UNITED STATES PATENT AND TRADEMARK OFFICE

APPLICATION NO.	FILING DATE	FIRST NAMED INVENTOR	ATTORNEY DOCKET NO.	CONFIRMATION NO.
10/698,382	11/03/2003	Chang-Bong Choi	IK-0068	2720
34610	7590	12/12/2005	EXAMINER	
FLESHNER & KIM, LLP P.O. BOX 221200 CHANTILLY, VA 20153			AYRES, TIMOTHY MICHAEL	
		ART UNIT		PAPER NUMBER
				3637

DETAILED ACTION

This is a second and final office action on the merits of application SN 10/698,382.

Koch '725 Figure 1

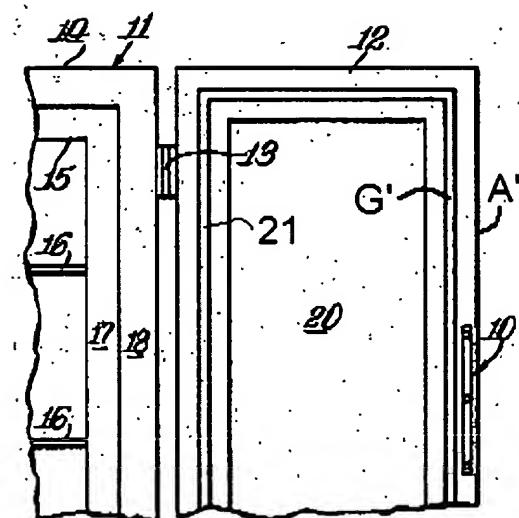
2. Claims 11, 12, and 17 are rejected under 35 U.S.C. 102(b) as being anticipated by US Patent 3,009,725 to Koch. Koch discloses a refrigerator with a door that pivots about an axis of rotation defined by hinge pin (13). A gasket (21) is mounted on the door (12) near all 4 outer edges of the door (12) and is in a position to make contact with the door and the main body of the refrigerator as seen in figure 1 and 3 to create a seal. Of particular focus is the section of gasket (G') in the marked up figure 1 below that is between the hinge pin (13) and the outer edge (A') of the door (12). A cushioning member (10) is positioned between the gasket (G') and the outer edge (A') of the door (12). The cushioning member (10) is in such a location as to preclude over compression of the gasket (G') when the door is pivoted shut. As seen in figure 3 when the door (12) is shut, the gasket is compressed slightly, if the cushioning member (10) was not there then the door (12) could be pressed in more allowing for over compression of the gasket (G') as seen in figure 3 below as the dashed line (D') representing the potential edge of the door (12).

4. Koch discloses a refrigerator with a door that pivots about an axis of rotation defined by hinge pin (13). A gasket (21) is mounted on the door (12) near all 4 outer edges of the door (12) and is in a position to make contact with the door and the main body of the refrigerator as seen in figure 1 and 3. Of particular focus is the gasket (G') in the marked up figure 1 above that is between the hinge pin (13) and the outer edge (A') of the door (12). A cushioning member (10) is positioned between the gasket (G') and the outer edge (A') of the door (12). The cushioning member (10) is in such a location as to preclude over compression of the gasket (G') when the door is pivoted shut. As seen in figure 3 when the door (12) is shut, the gasket is compressed slightly, if the cushioning member (10) was not there then the door (12) could be pressed in more allowing for over compression of the gasket (G') as seen in figure 3 above as the dashed line (D') representing the potential edge of the door (12).
